## York Street Interchange

Vector Re-Routing  
Proposal  
Assessment

October 2015

Figure 1: Vector Proposal

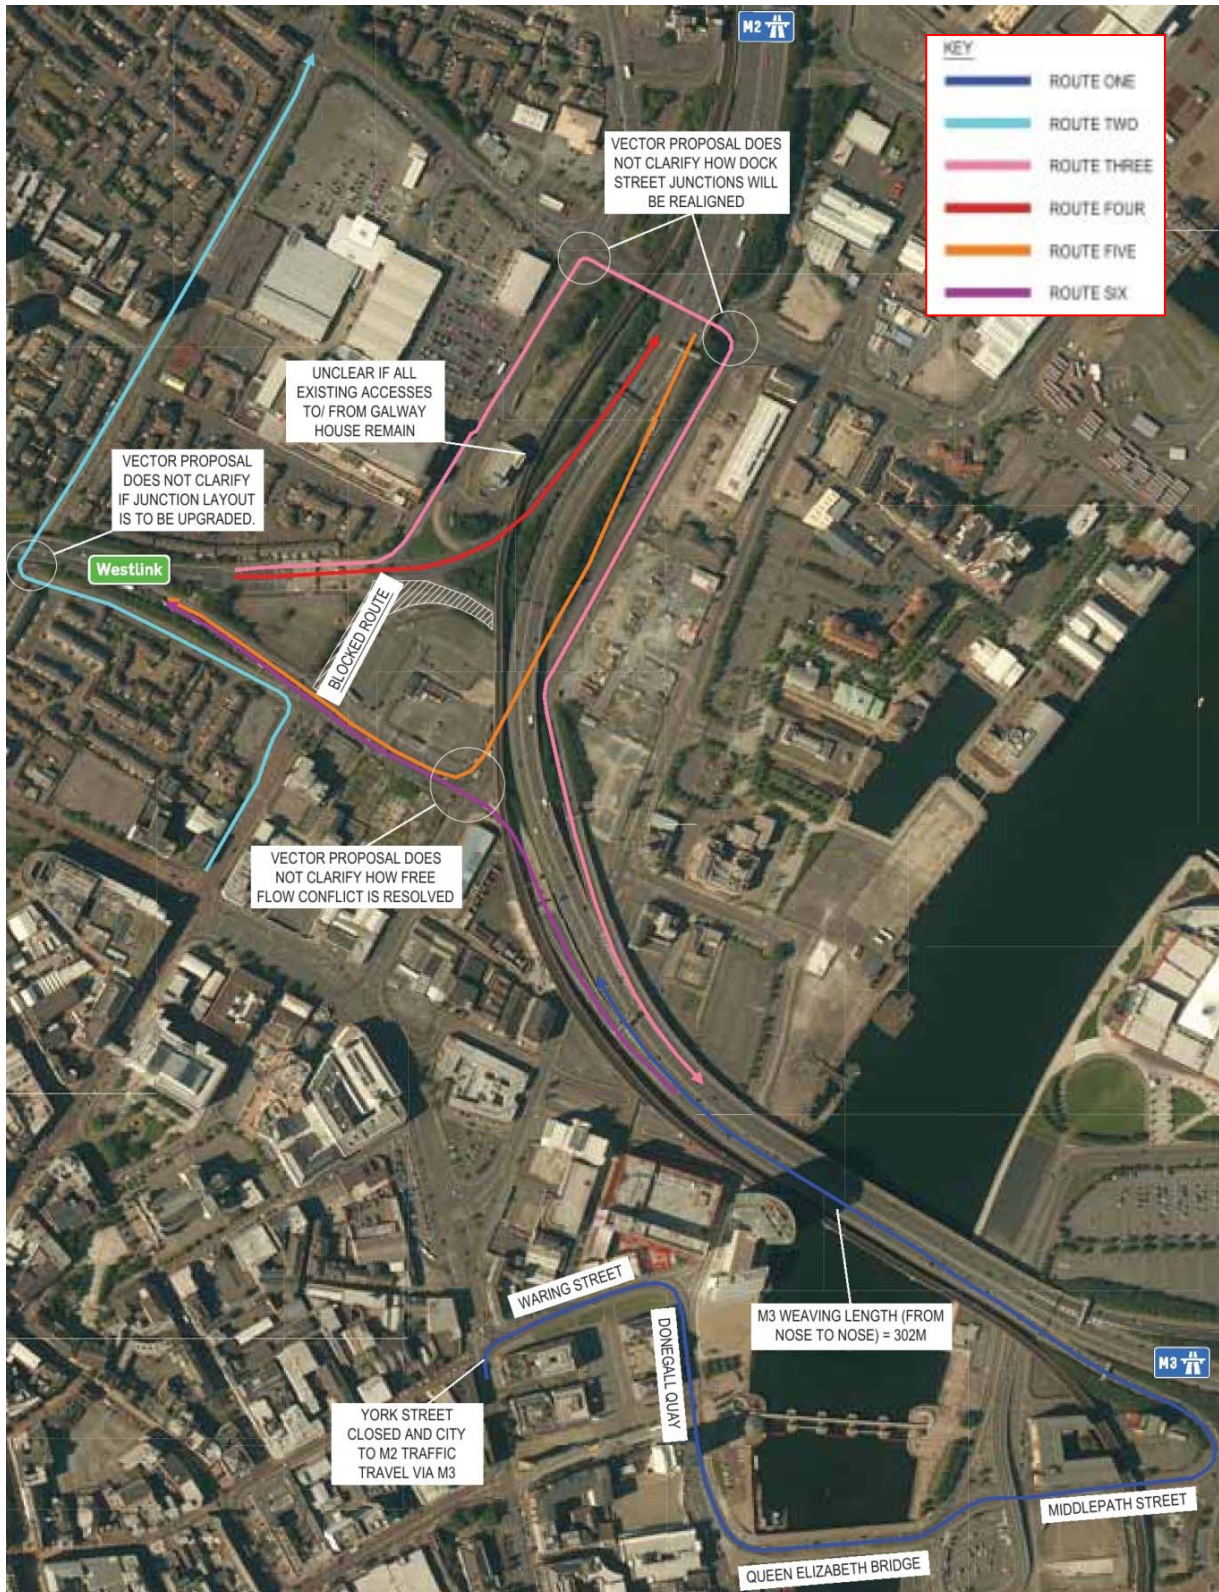
- The Vector Proposal requires significant changes to several existing signalised junctions. A number of these junctions would adopt an unconventional layout and it is unclear how these changes can be introduced in line with the engineering standards of the Design Manual for Roads and Bridges.

- Higher speeds and free-flow traffic may lead to greater risks for the safety of road users, particularly where free-flow is being introduced on unconventional junction arrangements.

- Route 1 in the Vector Proposal states that other traffic signals at Queens Square, Queens Quay, Station Street and Middlepath Street would be changed to “ad-hoc pedestrian lights”. These signals are currently used to manage road traffic conflicts that will still remain with the Vector Proposal and this is not considered feasible.

- Route 2 would require traffic reassignment onto Great Georges Street and North Queen Street. Currently these streets exist within a residential setting with traffic calming measures on North Queen Street.

Drawing Number: DRAWING 2

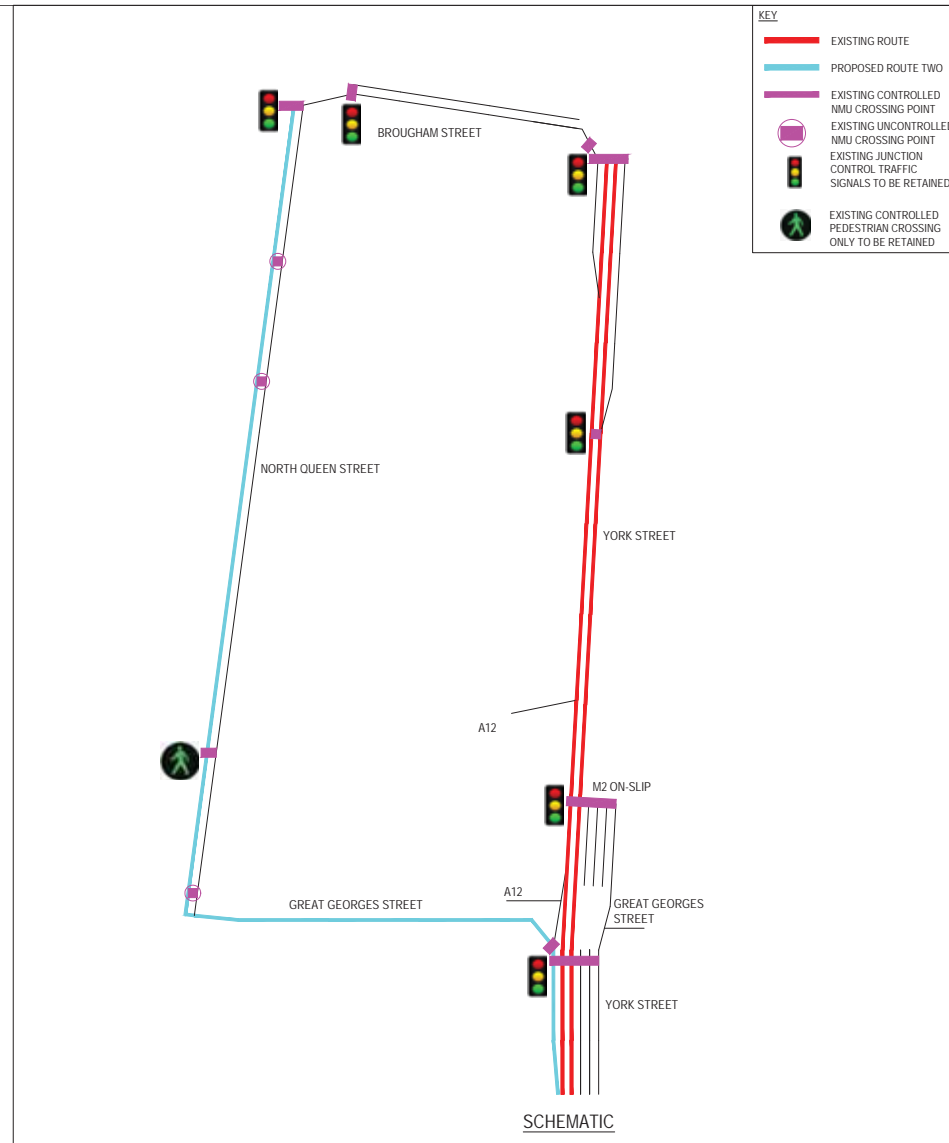
The information assessed does not provide details of lane provision on this alternate route. Further comment with regard to the resultant traffic impacts on the route are provided in Section 5. It may be a requirement to implement infrastructure changes along the route to improve, or attain, continuous lane provision between Waring Street and Middlepath Street. This may be especially important at Waring Street, where narrow lanes are currently signed.

Drawing 2 in Appendix A illustrates the Vector Proposal, along with a schematic diagram illustrating existing lane provision on the original and diversion routes.

Drawing Number  
**DRAWING 3**

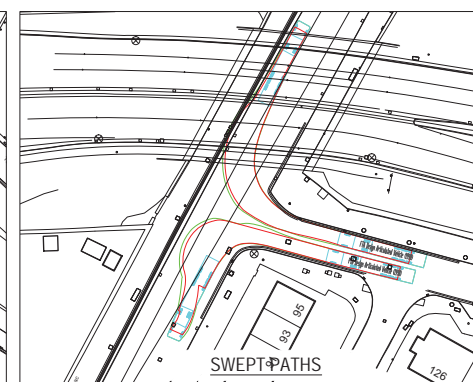
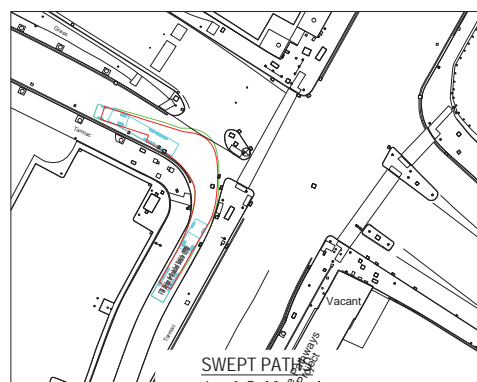
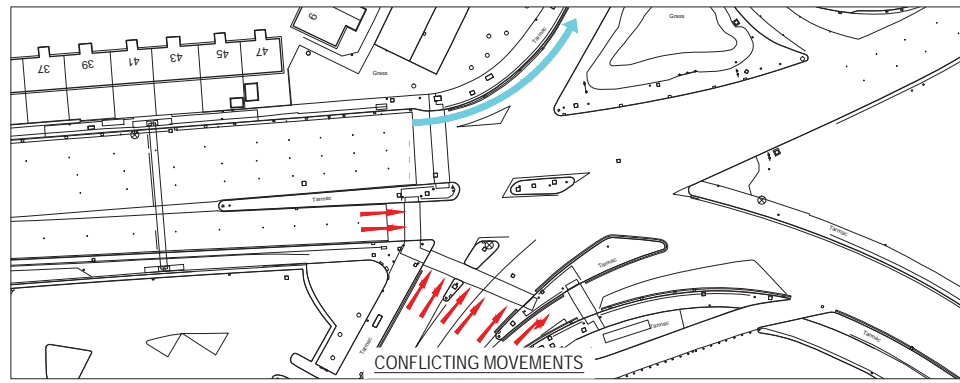
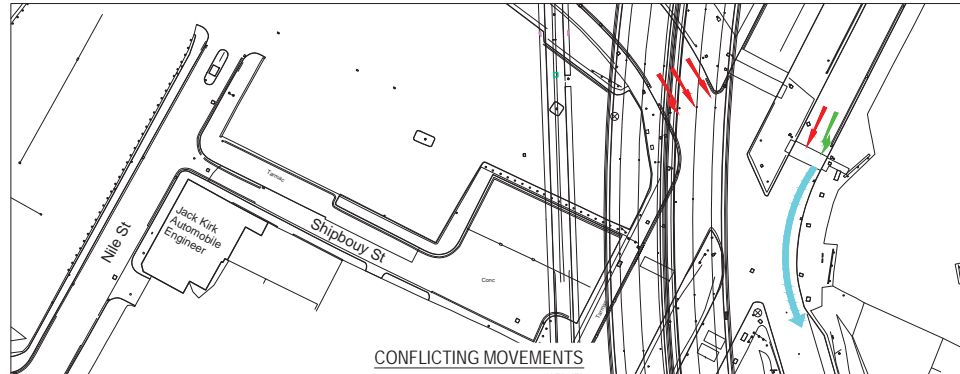
Drawing 3 in Appendix A illustrates the Vector Proposal, along with a schematic diagram illustrating existing lane provision on the original and diversion routes.

- the management of conflicting movements between the re-directed traffic on Great Georges Street as it joins traffic flows on North Queen Street;
- the ability for pedestrians to cross Great Georges Street along its length or indeed at the junctions at North Queen Street and York Street (in the absence of signal controlled crossings);
- the envisaged lane configuration on Great Georges Street is unclear from the information provided. Currently this operates as a wide single lane of approximately 9m (with on-street parking). This is illustrated in Figure 2;

- from a swept path analysis of the existing route, as illustrated on Drawing 3, it would not be possible for two lanes to be continuously provided between the junctions at York Street and North Queen Street;
- the Vector Proposal may introduce lane configuration requiring the extension of parking restrictions on Great Georges Street. This would require a period of public consultation and would be anticipated to meet with resistance from representatives of the local communities;
- it is considered that the re-routing of significant traffic volumes onto these existing residential routes introduces additional risks for road user safety, particularly non-motorised users; and
- the severance of York Street as part of Route 2 will impact upon existing public transport services for the area.

Drawing Number:				Rev:
<b>DRAWING 6</b>

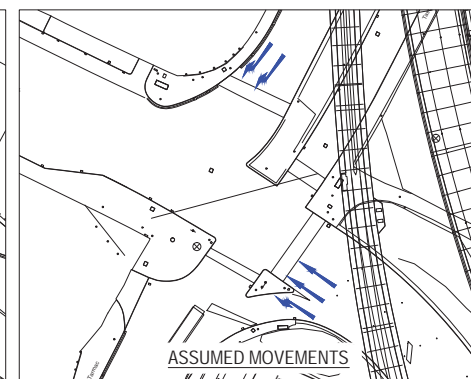
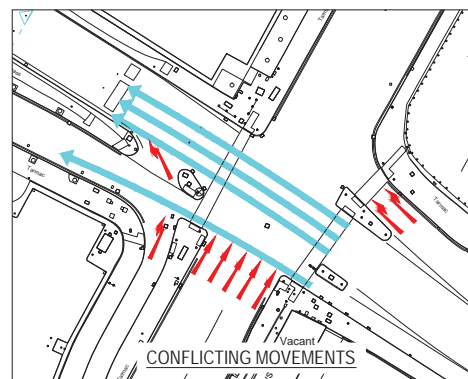
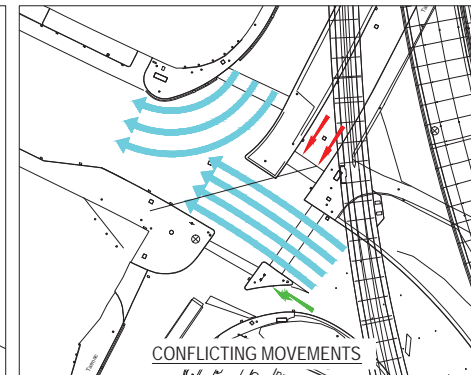
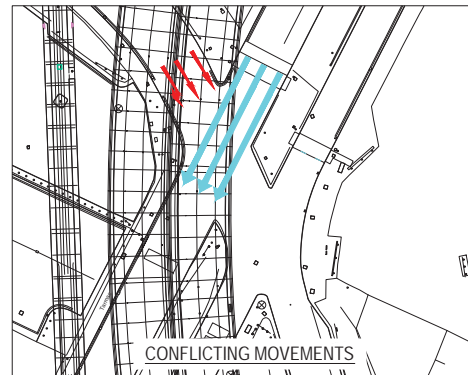
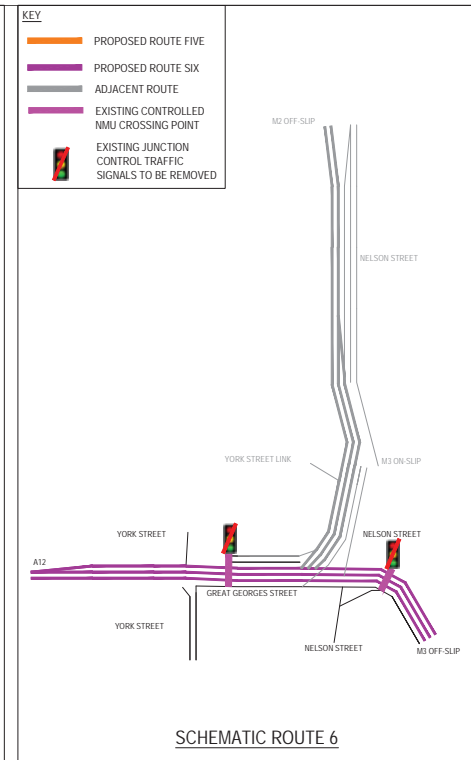
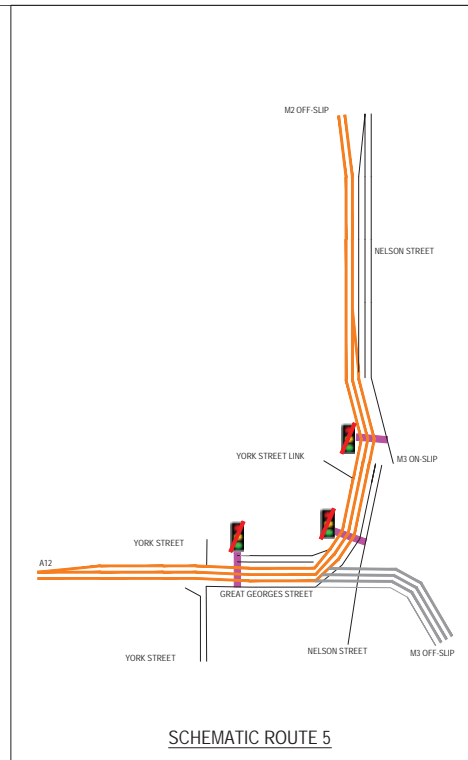
Drawing 6 in in Appendix A illustrates the Vector Proposal, along with a schematic diagram illustrating existing lane provision on the original and diversion routes.

The Vector Proposal does not provide sufficient details of lane configurations on Nelson Street and Great Georges Street. Based on the downstream capacity of the Westlink adjacent to York Street, only a maximum of three lanes can join the Westlink from Great Georges Street, reducing to two lanes at North Queen Street bridge. With the adjacent Route 6 providing a free-flow connection from the M3 to Westlink, it follows that only two lanes can be provided from Route 5, with lane two on the M2 to Westlink movement lost on approach to North Queen Street bridge. This lane reduction on the larger flows joining the Westlink from the M2 would likely create operational issues due to the effects of merging traffic.

In a similar manner to Route 5, the Vector Proposal does not provide sufficient details of lane configurations on the off-slip and Great Georges Street. This is particularly relevant given the downstream capacity of the Westlink away from York Street. With the adjacent Route 5 providing a free-flow connection from the M2 to the Westlink, with two lanes anticipated, it follows that only one lane can be provided from Route 6.

It would therefore follow that on the existing off-slip from the M3, the lane configuration would require alteration to reduce the number of lanes, similar to the Proposed Scheme. The Vector Proposal does not clarify the configuration but it could be reasonably assumed that the revised lane configuration on the off-slip would reflect that of the Proposed Scheme, with two lanes and a nearside auxiliary lane diverge. Of the two lanes, lane two would become the free-flow link to the Westlink and lane one would be designated for onward travel to Great Georges Street. The auxiliary lane diverge would be used to maintain the connection for City Centre via Nelson Street.
